**STATE OF ALASKA ITB NUMBER 2526H255
AMENDMENT NUMBER ONE (1)**

ITB TITLE: ANCHORAGE TAXIWAY Q RECONSTRUCTION SUPPLIES

The purpose of this Amendment #1 is to:

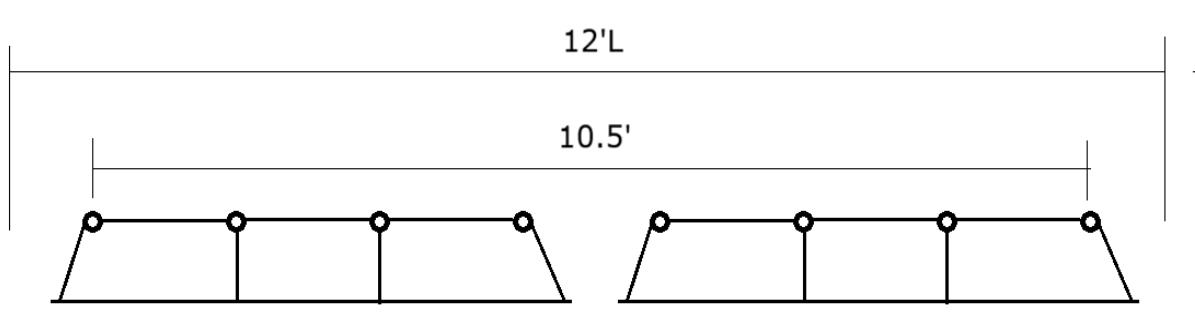
Question #1:

"Manufacturing dowel baskets in these lengths is cost-prohibitive and cannot be produced & shipped in this required deadline, due to changes of manufacturing equipment required.

These are possible with two smaller baskets installed with correct spacing per joint, see example detail below.

This example is a "10.5ft long basket w/ 8 dowels" per the RFQ, installed in a 12FT long joint, and referred to as 12 billable feet per the dowel manufacturer:

We can complete the current bid schedule provided, but please acknowledge and approve that each joint longer than 5 dowels will require an installed combination of two baskets, spaced appropriately."

Providing shorter baskets that still meet the required dowel spacing is acceptable. The supplier will need to provide a replacement conversion for each basket length being substituted (i.e. 10.5' baskets replaced with x.x' baskets, etc.).
